Historic Preservation Board

Wednesday, May 21, 2025 at 5:00 PM
Room 24 (Ground Level of City Hall) and
Zoom

- i. Certificate of Appropriateness for Revisions to Alterations; 308 Danforth Street; Richard N, Bryant, Trustee, 308 Danforth Trust & Nadine Knudsen, Applicant(s). Plan Number: HPBR-003052-2024.

**STAFF MEMORANDUM
HISTORIC PRESERVATION PROGRAM
PLANNING AND URBAN DEVELOPMENT**

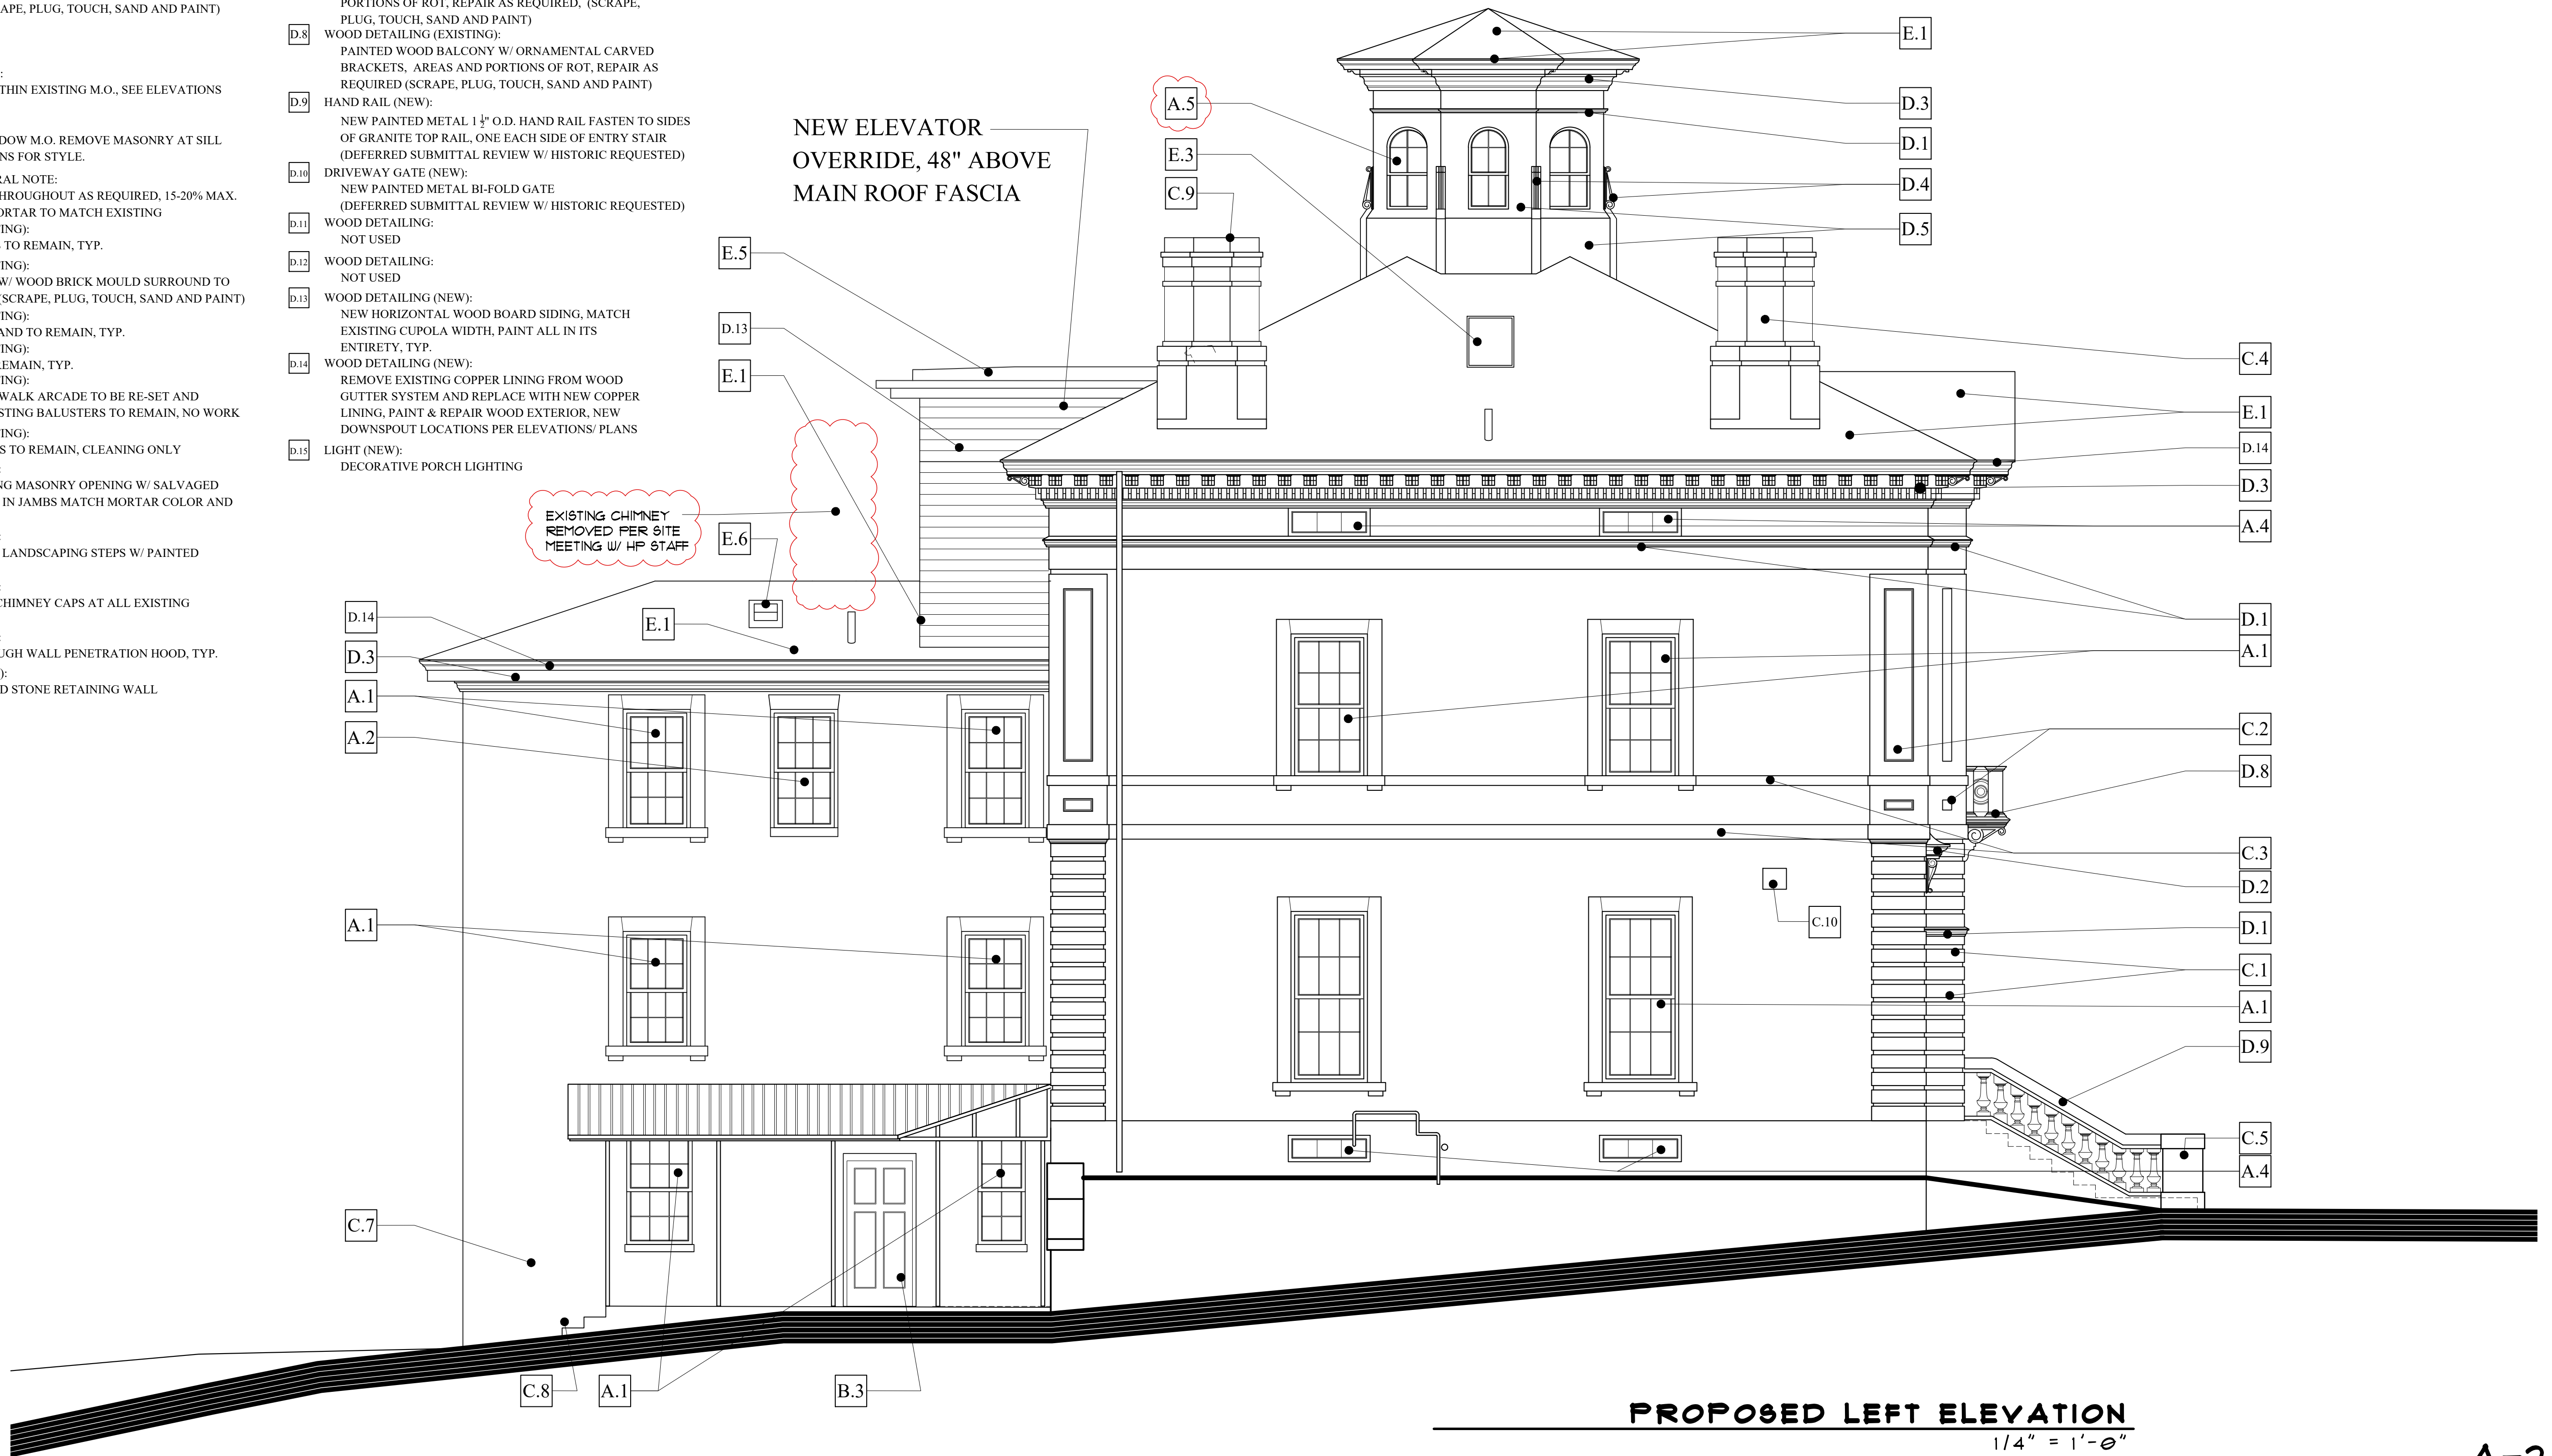
- 1) **Living Room Bay Window:** we are proposing to clarify the current permit to allow a 6/6 window muntin pattern; in lieu of the 2/2 pattern.

- 2) **Side Porch:** As the project has progressed, consistency has become a leading design philosophy for the owner. She is requesting an amendment to remove the side porch. The side porch is also located on the right elevation of the house. The owner appreciates the simplicity and appearance of the sister house, 300 Danforth at the similar building corner. The goal is to return 308 Danforth to the same simplicity.

- A.1 WINDOW (EXISTING):
REMOVE TOP & BOT. SASH, FRAME TO REMAIN (SCRAPE, PLUG, TOUCH, SAND AND PAINT) NEW 6/6 INSERT TYPE WINDOW, MASONRY OPENING AND DETAILS TO REMAIN
